Our ref: Demolition of existing structures and construction of 3 X RFBs at 300 Burns Bay Road, Lane Cove (SSD-87925706)

Subject: Request for Information

Appendix A

Image 1. DA530 – Cross Ventilation Diagram (Level 2- 6)

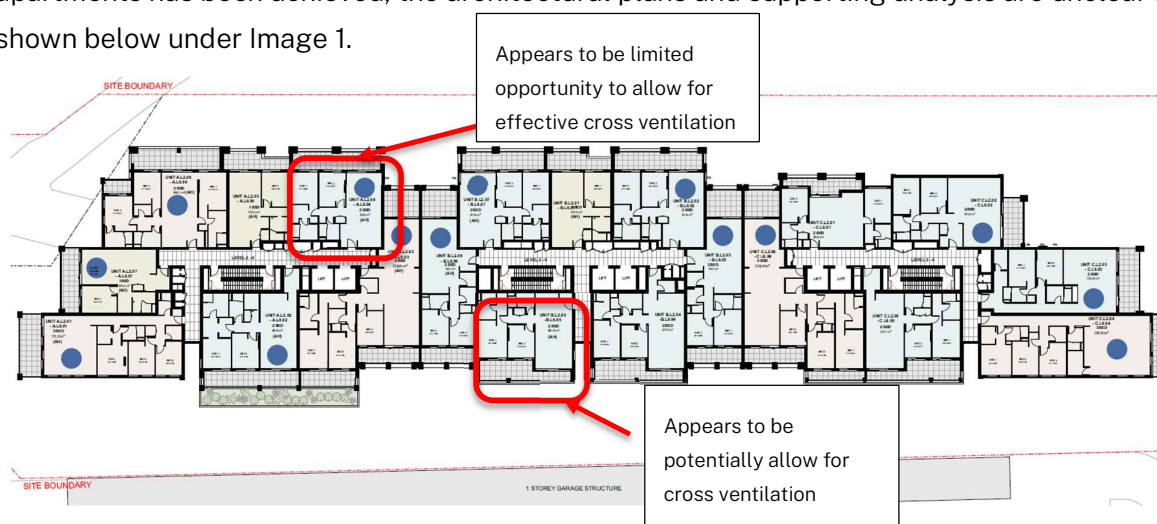
While the proposal states that the minimum required number of naturally ventilated apartments has been achieved, the architectural plans and supporting analysis are unclear as shown below under Image 1.

Several apartments appear capable of achieving natural cross ventilation, but this is not clearly shown in the submitted documentation. The documentation also does not include airflow arrows or sectional diagrams demonstrating cross ventilation outcomes and detailed plans to depict the inlet and outlet opening sizes, consistent with Figures 4B.3 and 4B.8 of the ADG.

- a) Amend the architectural floor plans to replace the existing blue dot notation with airflow arrows demonstrating natural ventilation paths consistent with Figure 4B.8 of the ADG.
- b) Additional plans depicting the Inlet and Outlet openings and area size as per Figure 4B.3 of the ADG.
- c) Submit amended plans and supporting documentation clearly demonstrating compliance with Part 4B of the ADG.
